GENERAL APPLICATION

The applicant is responsible for obtaining the appropriate	City Commission							
checklist for each type of	Explanation of Request: FINAL TAC REVIEW							
application.	Amendment to approvals O-2015-16 and R-2015-230							
Applicant(s) or their authorized legal agent must be	Number of units/rooms: 248 UNITS Sq Ft: 511,620 SF							
present at all Board or Committee meetings.	Value of Improvement: Estimated Date of Completion: JULY 2026							
ooninintee meetings.	Will Project be Phased? () Yes (X)No If Phased, Estimated Completion of Each Phase							
At least one set of the								
submitted plans for each	Name of Current Property Owner: 1817 TAYLOR ST DEVELOPMENT, LLC							
application must be signed and sealed (i.e. Architect or	Address of Property Owner: <u>1212 NW 82ND AVE, DORAL, FL, 33126</u>							
Engineer).	Telephone: 305-400-1397 Fax: Email Address: aensinck@me.com							
	Name of Consultant/Representative/Tenant (circle one): SANTIAGO TERAN

TECHNICAL ADVISORY SUBMITTAL: JULY 3RD. 2023

July 5, 2023

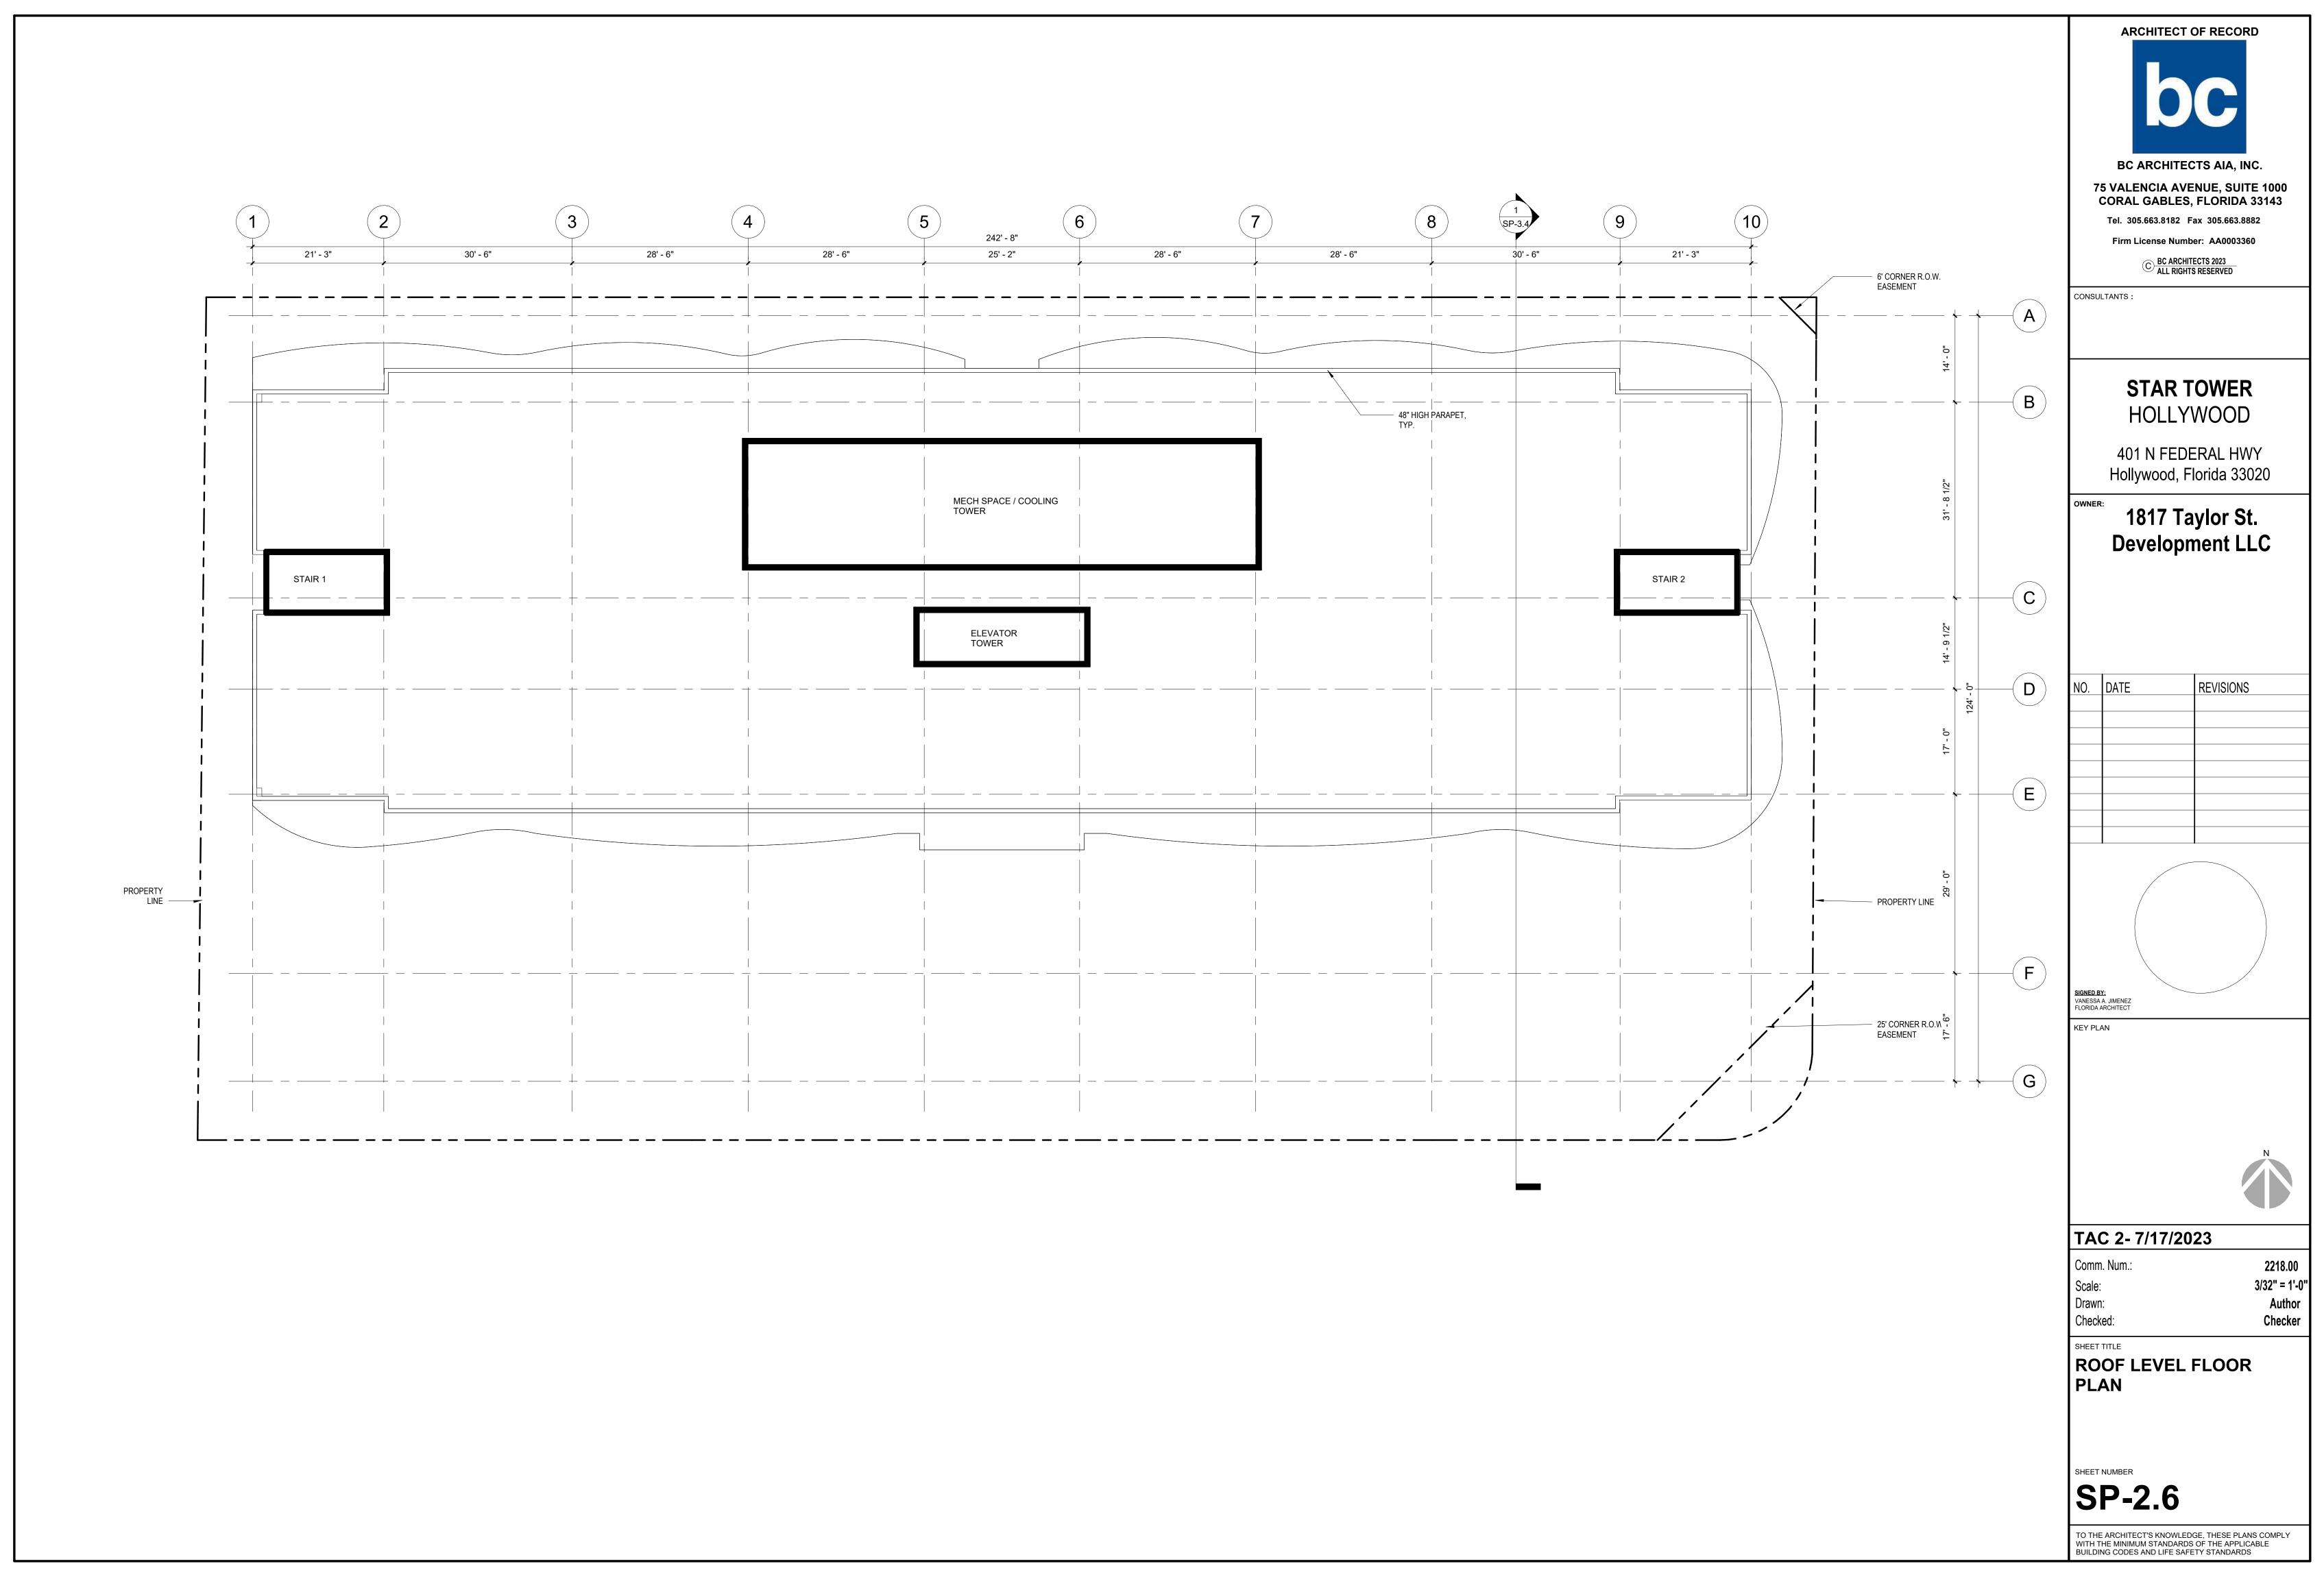
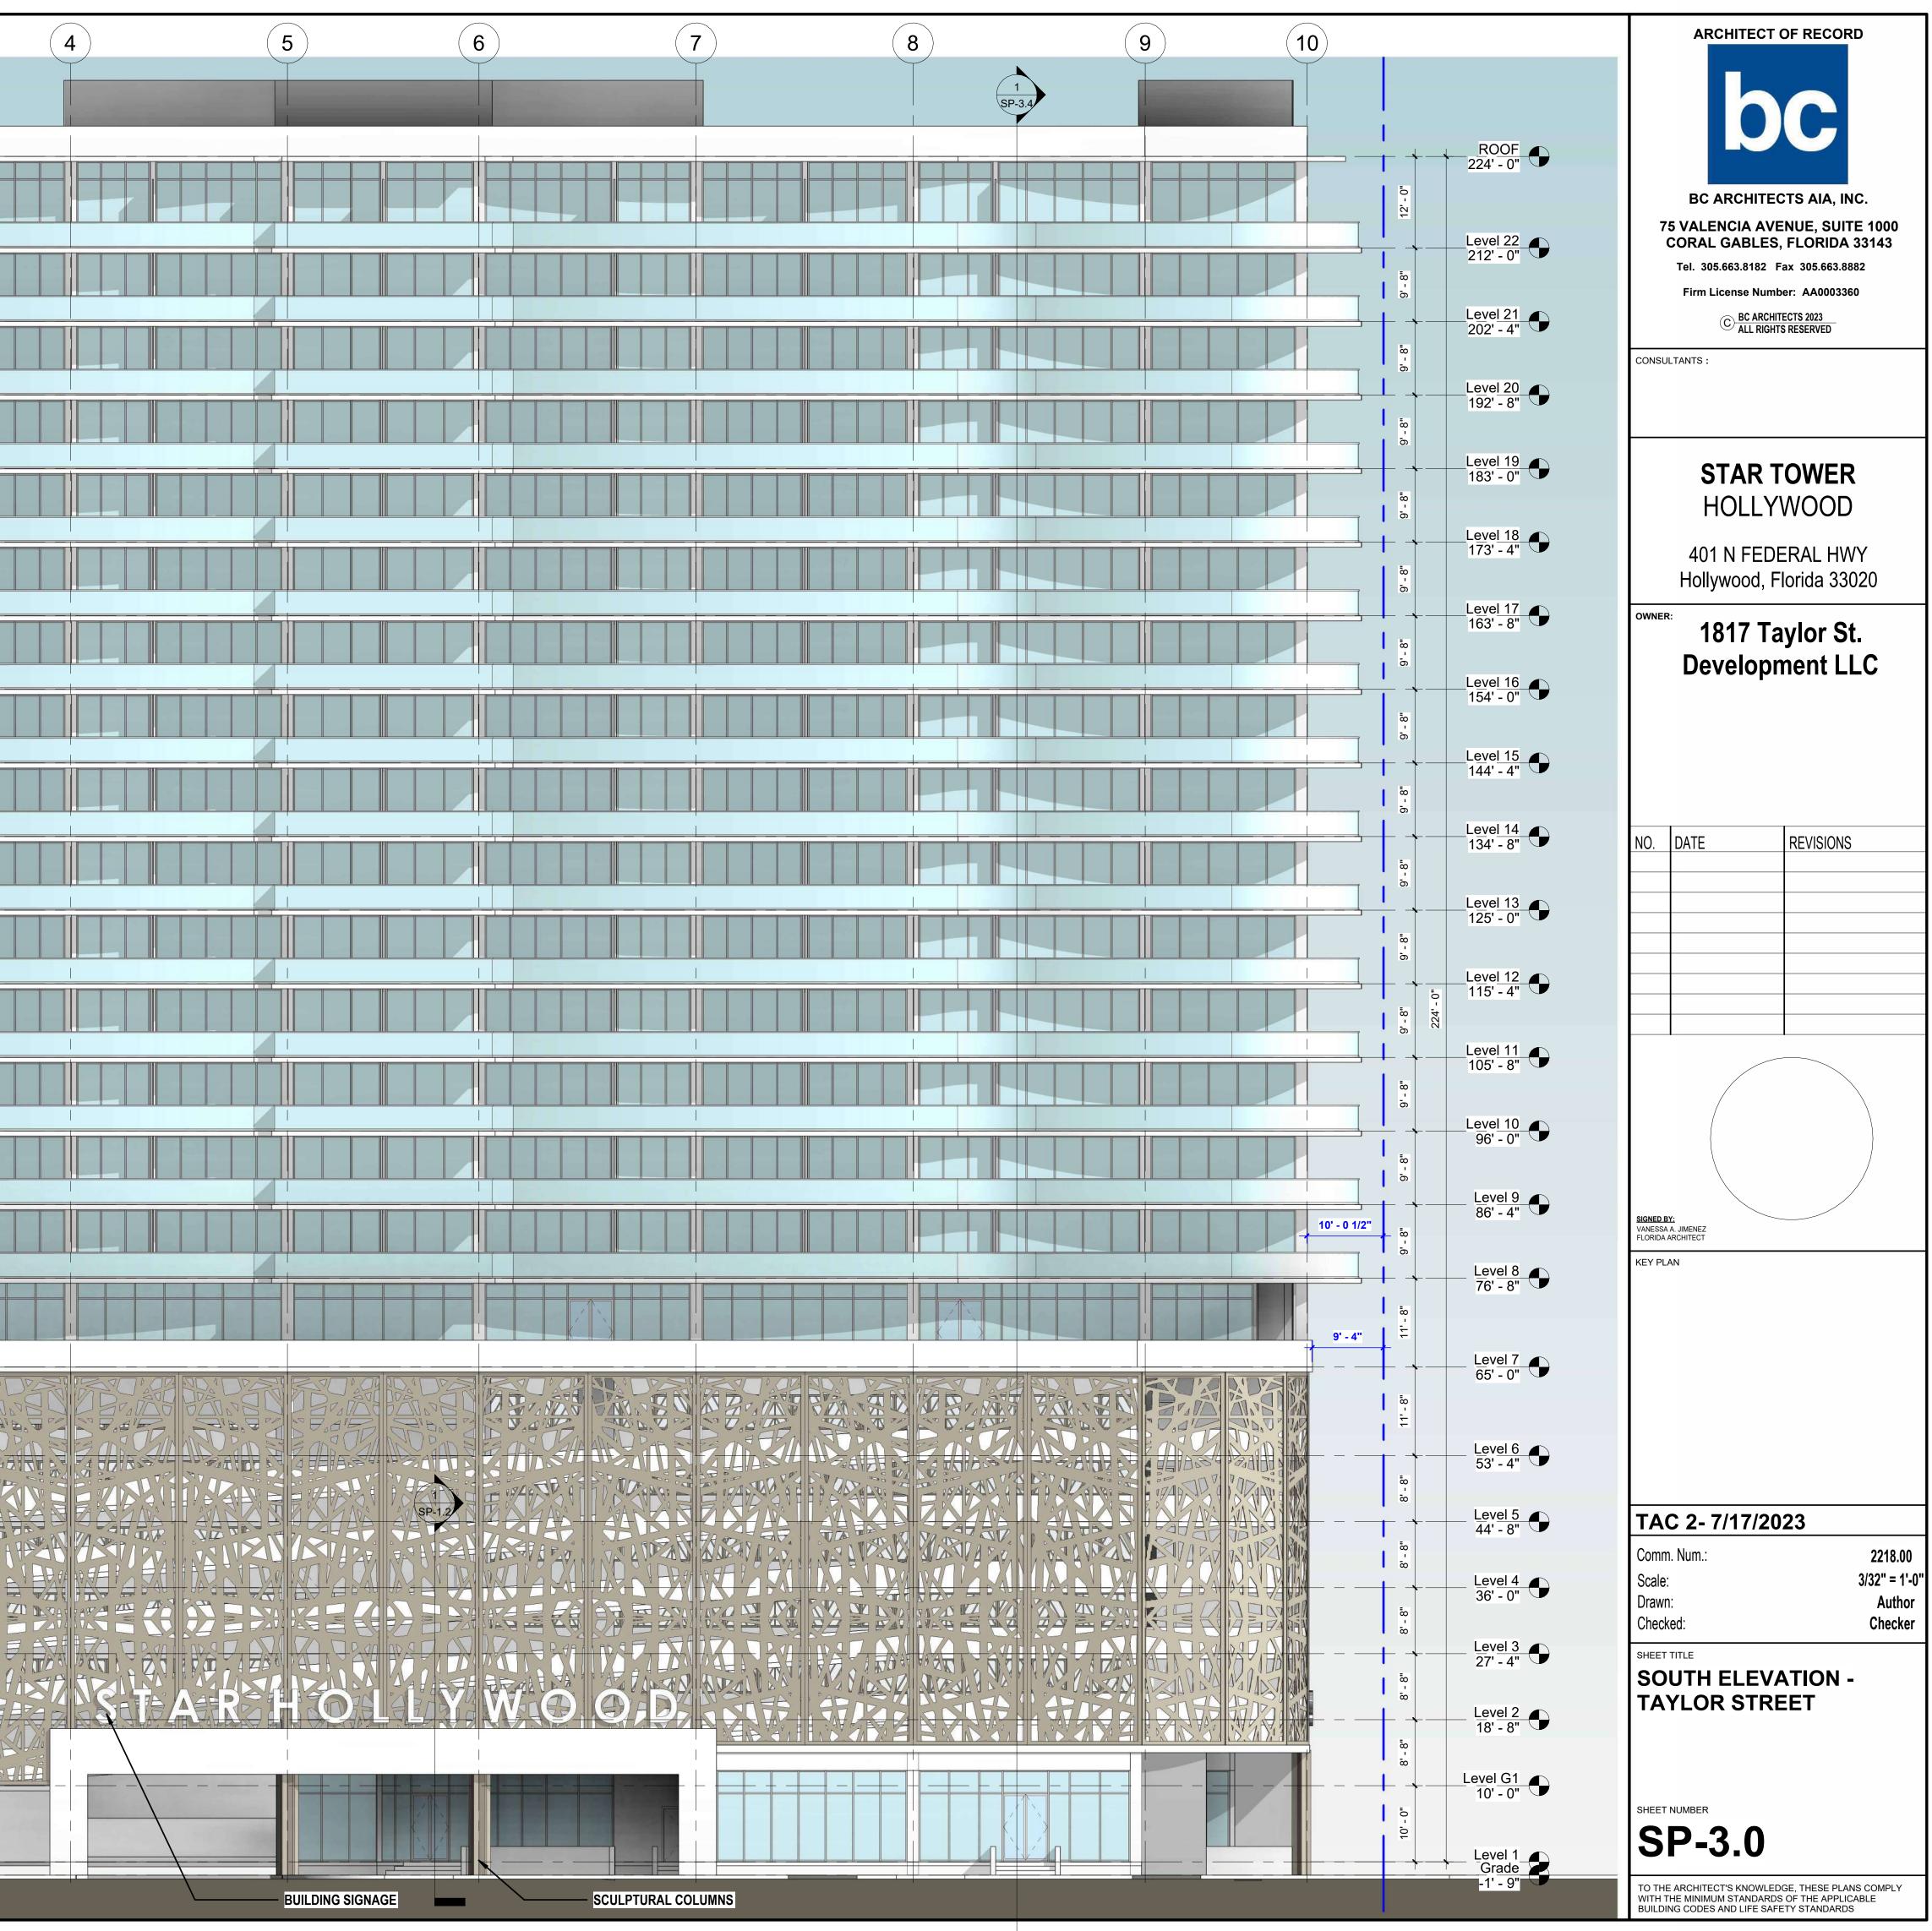
- 2. Include finished floor elevation for each level on the elevations. RESPONSE: See sheets SP-3.1-sp-3.4 for finished floor elevations.
- Provide location and height / size of all fences, walls dumpster enclosures and signage. RESPONSE: Please refer to the new Site Plan, sheet SP-101 & Hardscape Plan Sheet LH-101. A 5' Opaque fence is proposed along the western property line. Details of this fence is to be provided at the time of Building Permit.

- 4. Provide color and materials legend for all elevations **RESPONSE: See sheets SP-3.1-sp-3.4 for color notes.**
- 5. Provide more detail for the proposed metal screen. RESPONSE: See sheet SP-3.5 for enlarged view of screen and grilles.
